RESPONSE TO REQUEST FOR ADDITIONAL INFORMATION

APR1400 Design Certification

Docket No. 52-046

RAI No.: 61-7984
SRP Section: 08.03.01 – AC Power Systems (Onsite)
Application Section: 8.3.1
Date of RAI Issue: 07/06/2015

< The mobile generators are connected to Class 1E power distribution system train A or B.>

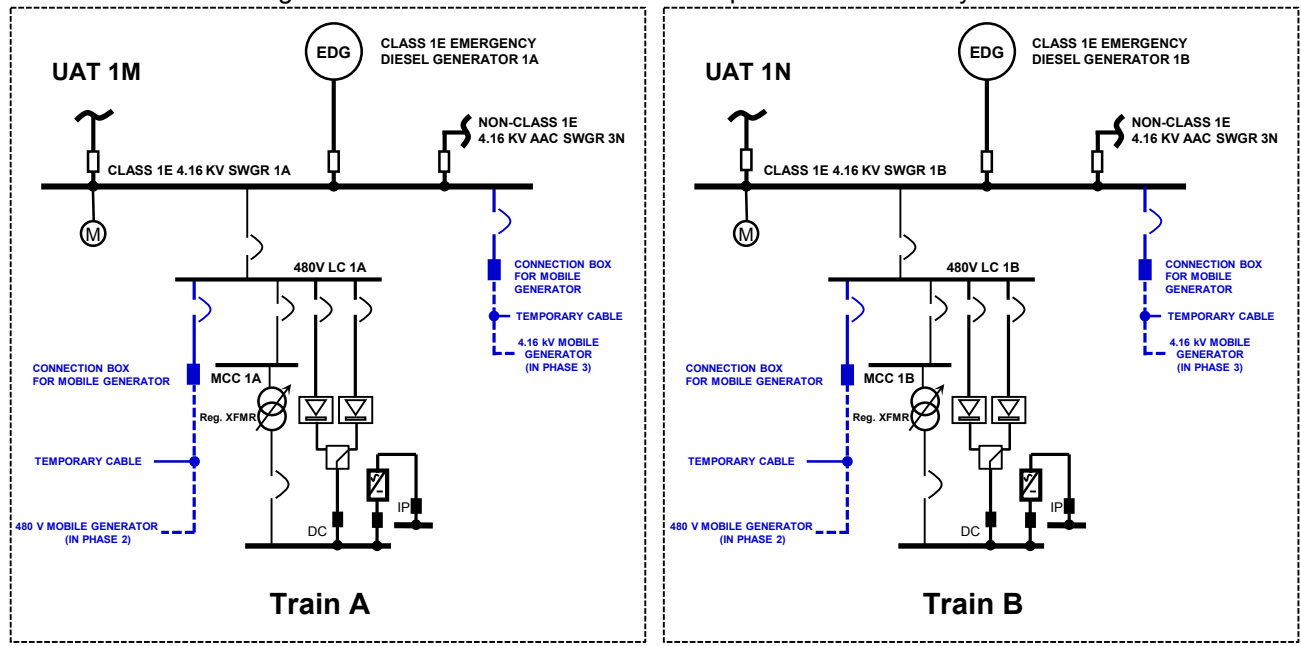
Provide a summary of the design aspects of the mobile generator, including anticipated physical location, connection configuration, the method of transferring the source to safety buses, specification of the equipment, details of support equipment.

Class 1E loads are divided into two redundant load groups (Divisions I and II). Each division has two independent subsystem trains: trains A and C (Division I) and trains B and D (Division II). The mobile GTGs are connected to the Class 1E power system train A or B at each phase of the mitigation strategies for BDBEES.

- Phase 2 : 480V mobile GTG connected to the LC bus
- Phase 3 : 4.16 kV mobile GTG connected to the SWGR bus

The mobile GTGs supply power to the Class 1E bus through connection boxes. Power cables between the connection boxes and the incoming circuit breakers of the Class 1E buses are permanent installations. Connections between the mobile GTGs and the connection boxes are implemented by temporary cabling.

To illustrate the preceding, a simplified single-line diagram is provided below.
